Response to Reviewer,

This study approximates glacial lake volume from simplified geometric representations of 4 main sub-types of moraine-dammed lakes, considering glacier-lake relationship (connected vs. unconnected) and lake width to length ratio. The performance of this new approach is reportedly better than the performance of other methods (comparison in Table 5).

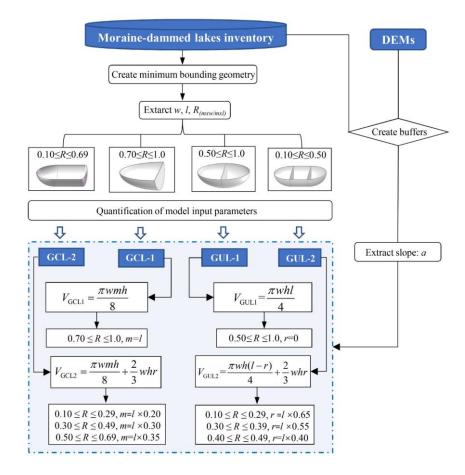
However, this is not surprising if the authors used the dataset of 44 Himalayan lakes with measured bathymetries to determine their parameters (section 3.3), and then use the same data to compare the performance of various methods (section 4.2). I hope I understood this correctly since the validation procedure is not described clearly in methods section. If I get it correctly, such performance evaluation is weak. A proper validation would require two independent datasets (training and testing).

Explanation and revision: Thank you very much for your questions and suggestions. The main reason for the misunderstanding is my lack of logical clarity and precision in wording, for which I sincerely apologize for the confusion caused.

First, regarding the determination of model input parameters, we have provided a detailed explanation in Section 3.3 of the paper. The unknown parameters in the model are w, l, a, m, n, and r, all of which can be extracted from glacier lake boundaries and DEM data. For example, we measured w and l by drawing a minimum rectangle bounding box with length l encompassing the MDL (see Figure 4). To determine the slope a-value surrounding the MDL, we used a DEM with a spatial resolution of 12.5 m in the model computation. The detailed extraction steps can be found in Lines 230-238. Determining the appropriate thresholds for m, n, and r for different MDL types is challenging, as methods for extracting these parameters vary depending on the MDL types. In other words, due to the different types of glacial lakes, the values of m, n, and r vary. Additionally, these values change with the size of the glacial lake. To enable the model to automatically identify and calculate the corresponding m, n, and r for each glacial lake, we need to define a threshold. Based on the geometry of the glacial lake, we established a proportional relationship (Table 3) between m, n, r, and the glacier lake length (l). This proportional relationship is empirically defined and essentially represents a geometric segmentation of the glacial lake. The lake is divided into three sections, and the volume of each section is calculated separately. The total water storage of the lake is then obtained by summing the volumes of these three sections.

To sum up, there is no parameter that needs to be trained or optimized, all parameters can be measured through the glacial lakes and their surrounding topology. The validation of the model is based on an independent dataset. The primary data and workflow for determining the parameters in the model are shown in the figure below.

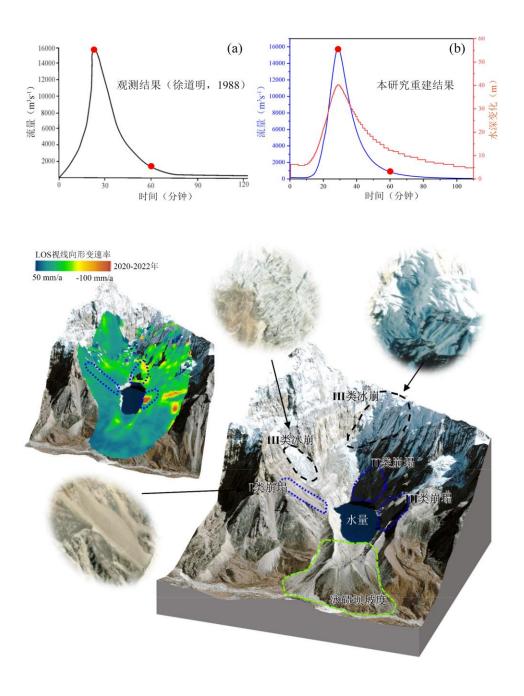
The application section 4.3 is not linked to the methodology. It is not clear what was done and whether (and how?) all 13,166 lakes mapped by Wang et al. (2020) were classified according to the classification scheme used in this study and whether all these are moraine-dammed lakes?

Explanation and revision: Thank you very much for your review. We have added Section 3.4 of the methodology to link model application. In this study, we used Wang's data to estimate the water storage of moraine-dammed lakes in the High Mountain Asia region. His dataset has rigorously classified GCL and GUL. It is important to note that in his dataset, GUL refers specifically to glacier lakes that do not contact glaciers, which may not necessarily all be moraine-dammed lakes. We conducted a thorough review and made revision to ensure that we retained only those GULs classified as moraine-dammed lake.

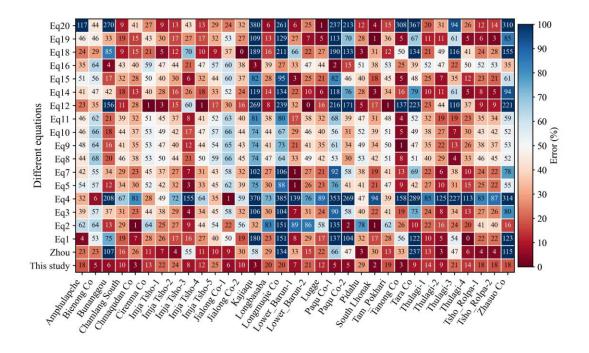
Figure 8: I don't understand what is the meaning of these box plots unless it is connected to measured data? The XY graph type (inset) is way more meaningful and the authors may consider showing a panel with performance of all methods in XY graphs.

Explanation and revision: I used box plots to represent the range of water storage estimates for each method, highlighting the differences between various approaches. Figure 8a shows significant variations among the methods, where it is clearly evident that some methods yield much larger estimates than our model, potentially resulting in order-of-magnitude discrepancies in the estimated water storage for individual lakes. The results from our model, by contrast, show a more concentrated distribution compared to the other methods. Figure 8b presents a comparison between our model's estimates and the measured values, specifically demonstrating the model's strong performance. We also experimented with other visualizations to compare the different methods, but overall, none were as effective as the box plot.
